Subject: Duke Energy Carolinas, LLC
Oconee Nuclear Station, Units 1, 2, and 3
Docket Nos. 50-269, -270, and -287
Emergency Plan Implementing Procedures Manual
Volume A, Revision 2014-001

**SUBJECT: Emergency Plan Implementing Procedures
 Volume A Revision 2014-001**

OCONEE NUCLEAR STATION TYPICAL TECHNICAL SUPPORT CENTER PRIMARY LOCATION UNIT 1&2 OPS CENTER

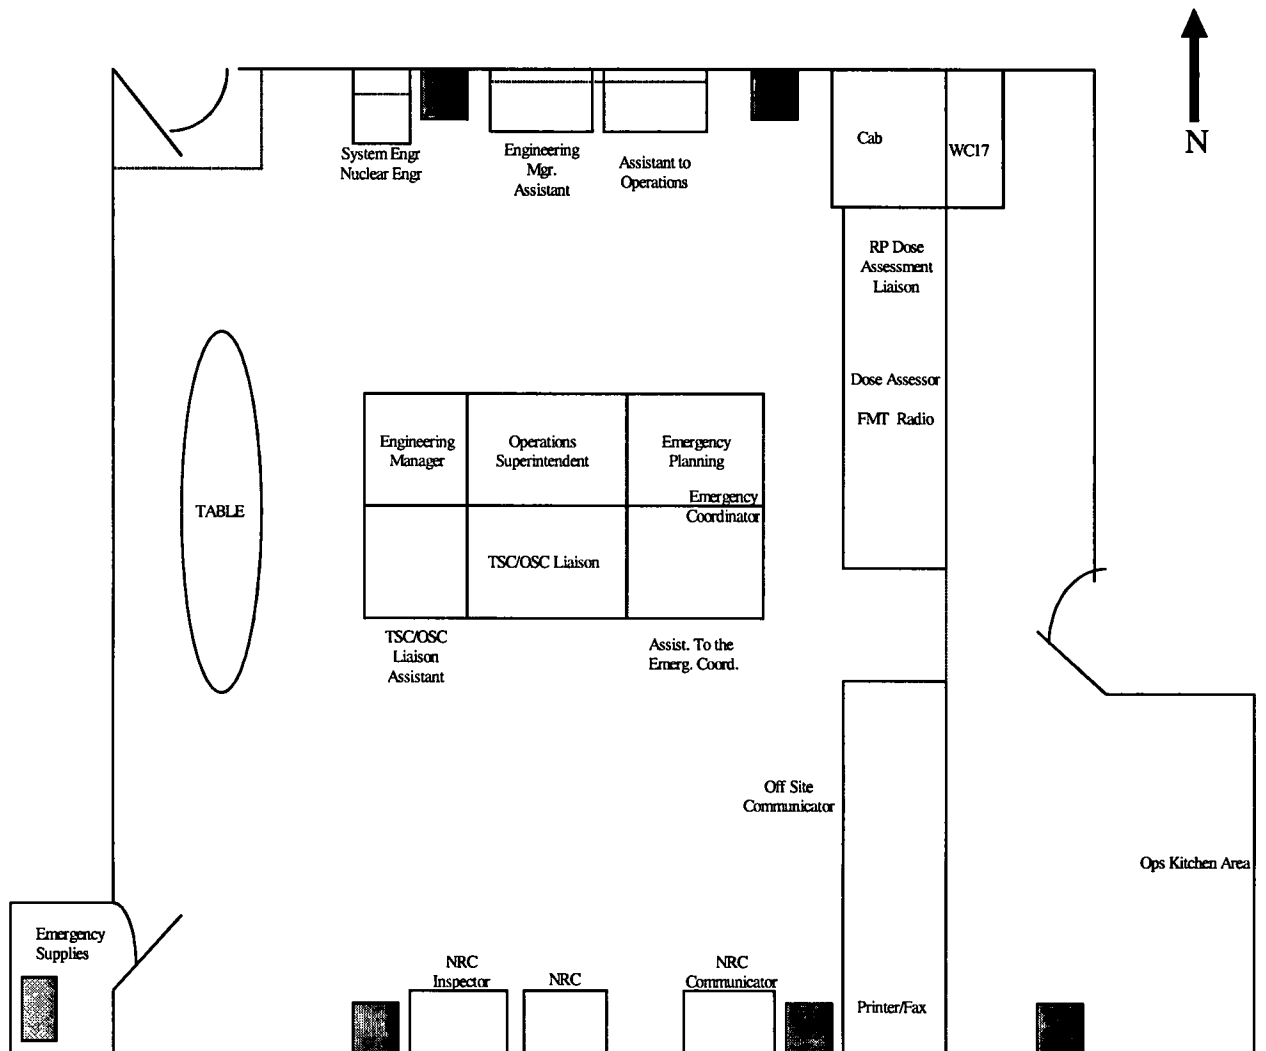
8	Section H Emergency Facilities and Equipment	NA	<ul style="list-style-type: none"> Removed implementation details from TSC and OSC drawings. Revised titles to indicate these are typical drawings of the TSC/OSC to enable flexibility in set up. Removed alt TSC and alt OSC drawings as these are rooms and can be setup as needed. Revised procedure numbers SR/0/B... to ST/0/A... Corrected misalignment on H-20 	Enhancements -removing implementation details from within the E Plan to other documents reduces work effort . Corrected Typo on procedure number and misalignment on Figure H-20.
9	Section J Protective Response	RP/0/B/1000/010 RP/0/B//1000/009 NA	RP/0/A/1000/010 RP/0/A/1000/009 J.7 FigureJ-1A...avoided dose. Per Appendix 2 initial protective actions are predetermined for Control Room use... and to shelter	Editorial - updated procedure numbers Added a more clear tie to Appendix 2.

FIGURE M-2
DUKE ENERGY COMPANY
OCONEE NUCLEAR STATION
OFFSITE RECOVERY ORGANIZATION

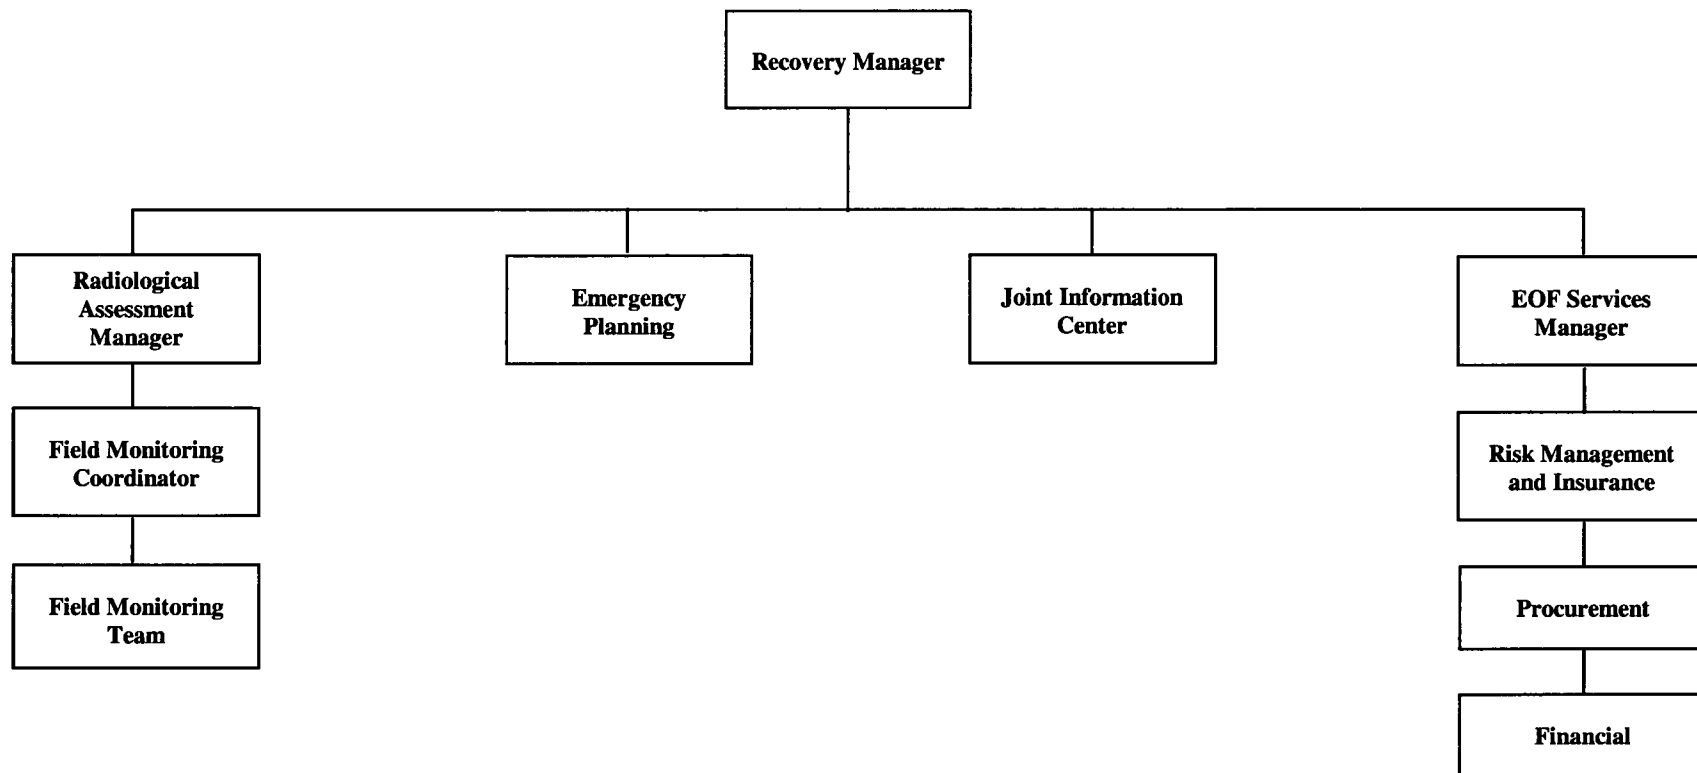
Change #	Document Number / Section	Current Wording	Proposed Wording	Reason for Change
10	Section M Recovery and Reentry Planning and Post Accident Operations	RP/0/B/1000/019 Insurance	RP/0/A/1000/019 Updated titles and responsibilities in Figure M-2; Risk Management and Insurance Procurement, Financial	Editorial updated procedure number Enhancement to show the various necessary departments.
11	Section P Responsibility for the Planning Effort	<ul style="list-style-type: none"> • P.9...Guidance for performing the assessment against performance indicators is provided in the EP FAM • Figure P-1 old procedure references RP/0/B... • Figure P-1, HR Emergency Plan • NA 	<ul style="list-style-type: none"> • P.9...Guidance for performing the assessment against performance indicators is provided in Emergency Preparedness Administrative Procedure AD-EP-ALL-0001 • Figure P-1 RP/0/A... • (eliminated reference to HR Emergency Plan • Added reference to P9 in Figure P1. 	Editorial - Moving to fleet formatting of procedure and associated numbering. Editorial up dates to the procedure numbers. Eliminated reference to HR Emergency Plan as the implementing procedures for assembly / accountability and evacuation for all personnel is contained in RP procedures.
